Historic Landmark Commission
February 27, 2012
National Register Historic Districts
NRD-2012-0015
West Line
1601 Waterston Avenue

PROPOSAL

Repair and repaint siding, install new windows and doors, and add new stairs to front and rear entry.

2 PROPOSED - WEST ELEVATION
1/8" = 1'-0"

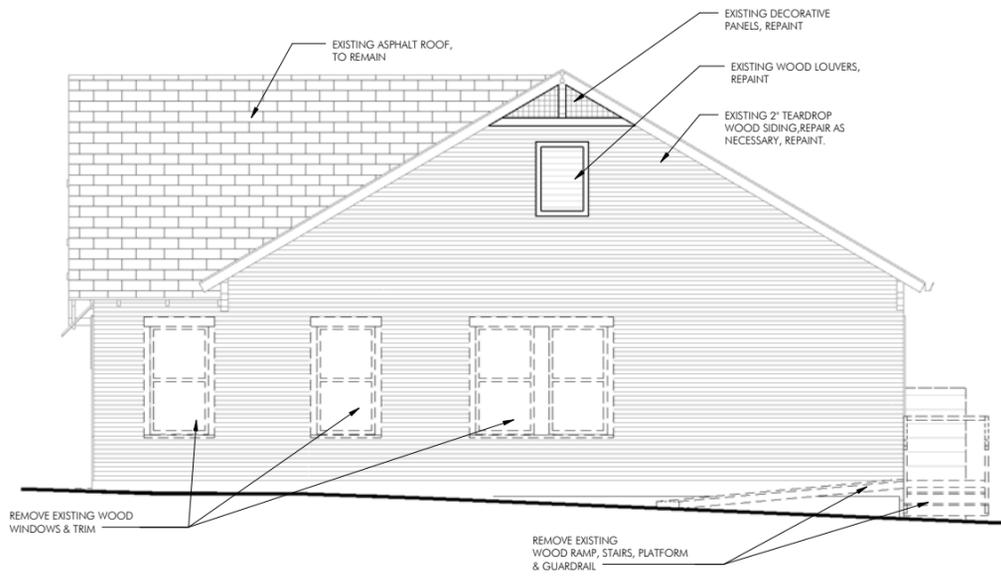
Staff recommends approving release of the permit per the proposed plans, however the applicant is requested to eliminate at least the first set of French doors on the west elevation, and maintain the existing window to minimize impact to the historical appearance from the street.

2 PROPOSED - EAST ELEVATION
1/8" = 1'-0"

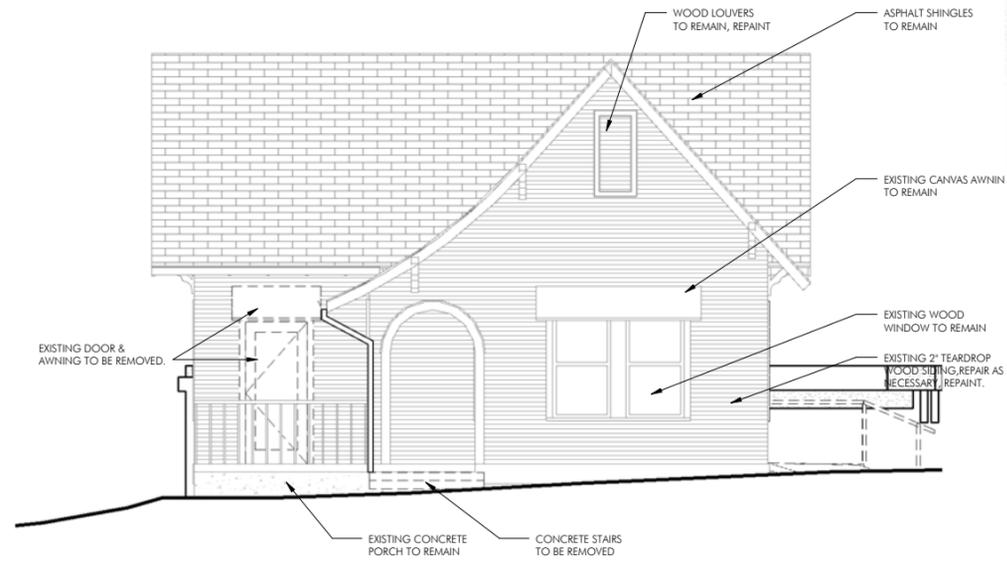
The majority of the work proposed has minimal impact on the historic integrity of the building. Relocation of the front door is appropriate as the location of the existing door is likely not historic. Installation of the French doors on the side elevation has the greatest impact to the building's historical integrity.
